Model: Dolphin		Date: 23-Aug-01	No.: RB010001
Subject: Service Manual		Prepared by: F. Noguchi	
From: Technical Services Dept., GTS Division			
Classification:	<input type="checkbox"/> Troubleshooting	<input type="checkbox"/> Part information	<input type="checkbox"/> Action required
	<input type="checkbox"/> Mechanical	<input type="checkbox"/> Electrical	<input checked="" type="checkbox"/> Service manual revision
	<input type="checkbox"/> Paper path	<input type="checkbox"/> Transmit/receive	<input type="checkbox"/> Retrofit information
	<input type="checkbox"/> Other ()

The sentences in *italics* show recent corrections to the Service Manual. Please correct your manuals accordingly.

Page 1-25 1.7.2 INSTALLATION PROCEDURE

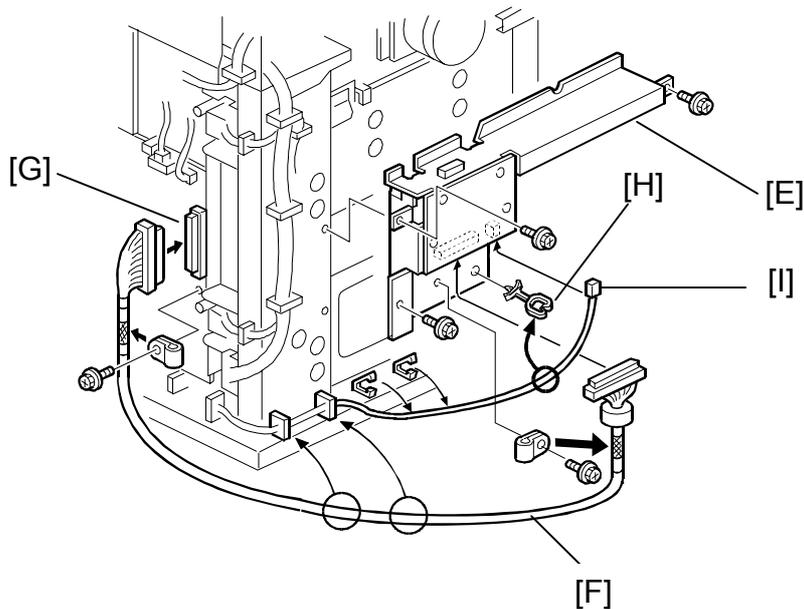
Corrected: Step 5 and illustration

5. Install *the wire saddle* [H] and connect the DC harness [I] from the main frame to the I/F board.

Page 6-53 6.10.6 HOT ROLLER THERMOFUSE

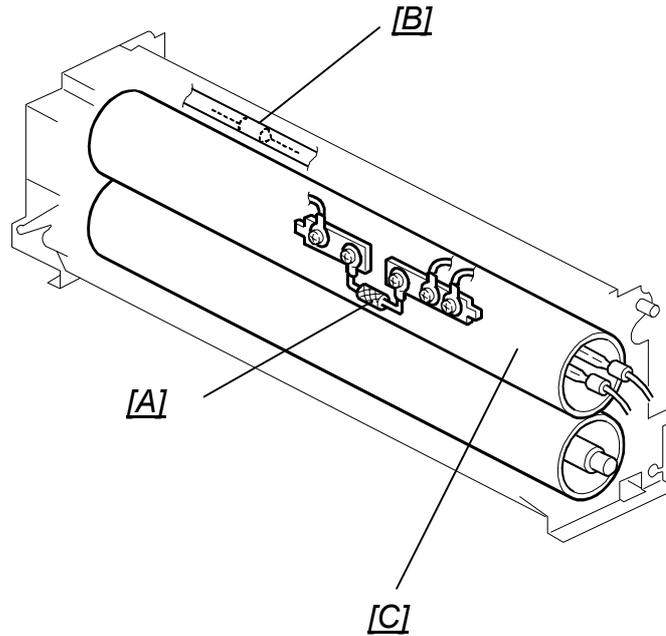
Corrected: Description and illustration.

Non-contact thermofuses (rated for 192°C [A] and 216°C [B]) near the hot roller [C] prevent accidental overheating which may lead to a fire hazard.

Illustration correction:

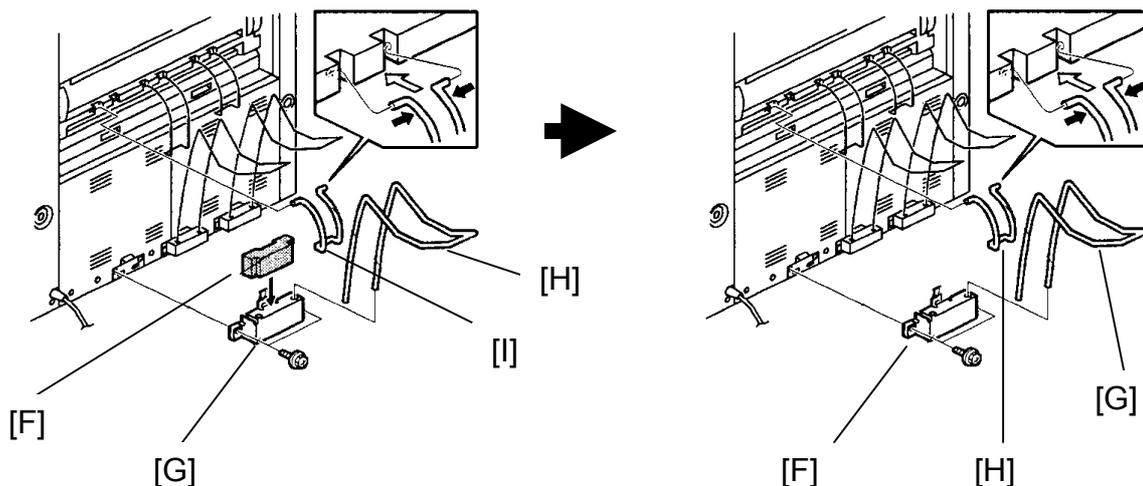
Delete Step 16: “Adhere the cushions [F] to the rear copy tray holders [G].”

Delete the cushion [F] (B010I206.WMF) from the illustration.

2. Addition: Key Counter Installation Procedure

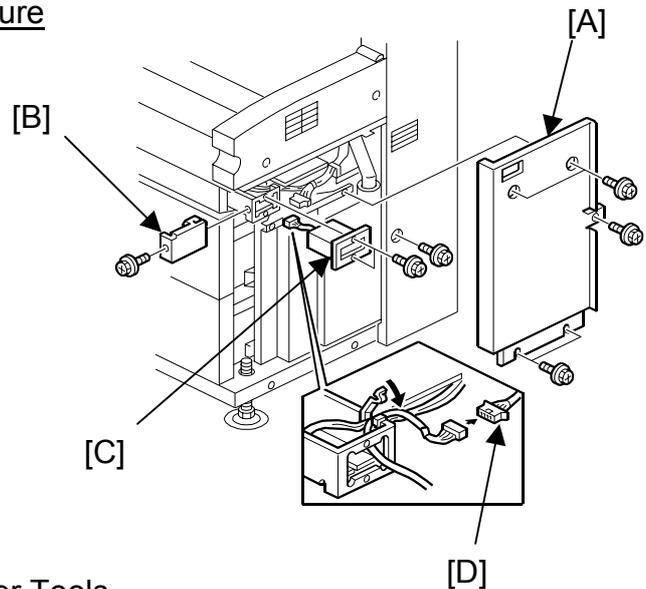
- 1) Remove the right front cover [A] (5 screws).
- 2) Remove the small cover [B] (1 screw) and plate nut (2 screws).
- 3) Install the key counter holder [C] by attaching it to the bracket (2 screws, 1 connector [D]).
- 4) Reinstall the right rear cover.
- 5) Instruct the key operator on how to enable the Key Counter from inside User Tools.
(User Tools → System Settings → Key Operator Tools → Key Counter Access)

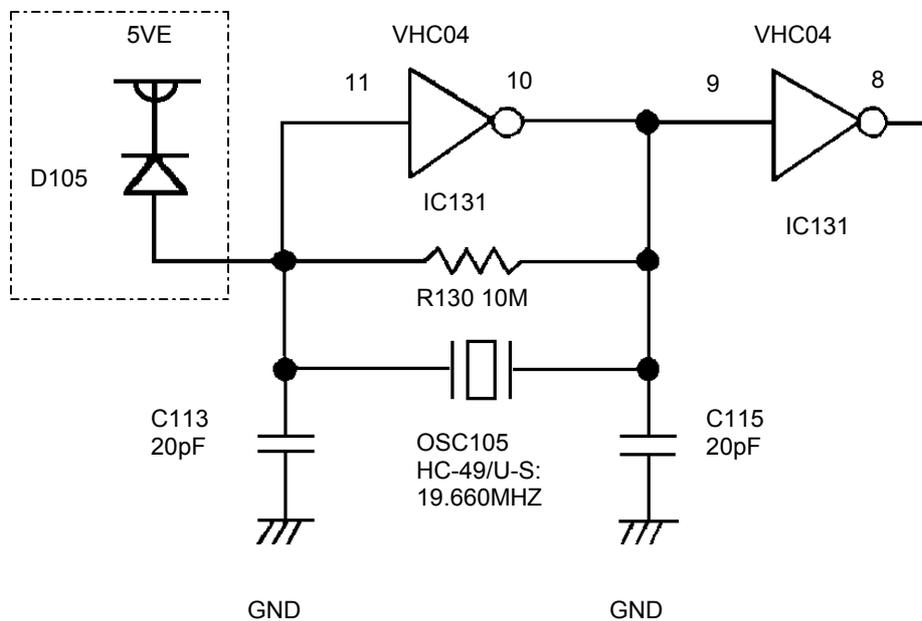
The machine shuts down after the MCU breaks (only the operation switch LED is lit).

At power off, surge current damages the oscillator circuit IC on the MCU.

Replace the MCU with the modified one (suffix C) at installation or the next customer visit.

Shield Plate
P/N B0101066

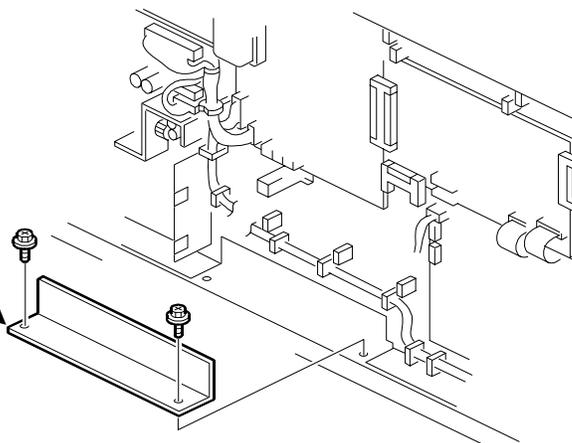
To further minimize the effect of electrical noise, a Shield Plate has been added in front of the HDD attachment area. Since this plate is not used when the HDD option is present, please add Step 4 to the following Service Manual HDD Installation Procedure:

1. Remove the copier right and left covers (9 screws).
2. Remove the serial number decal from the HDD unit and attach it on the rear frame, next to the machine's serial number decal.
3. Remove the 2 cushions from the HDD unit.
-  4. Remove the shield plate (2 screws).
5. Install the HDD unit onto the base plate (2 screws)
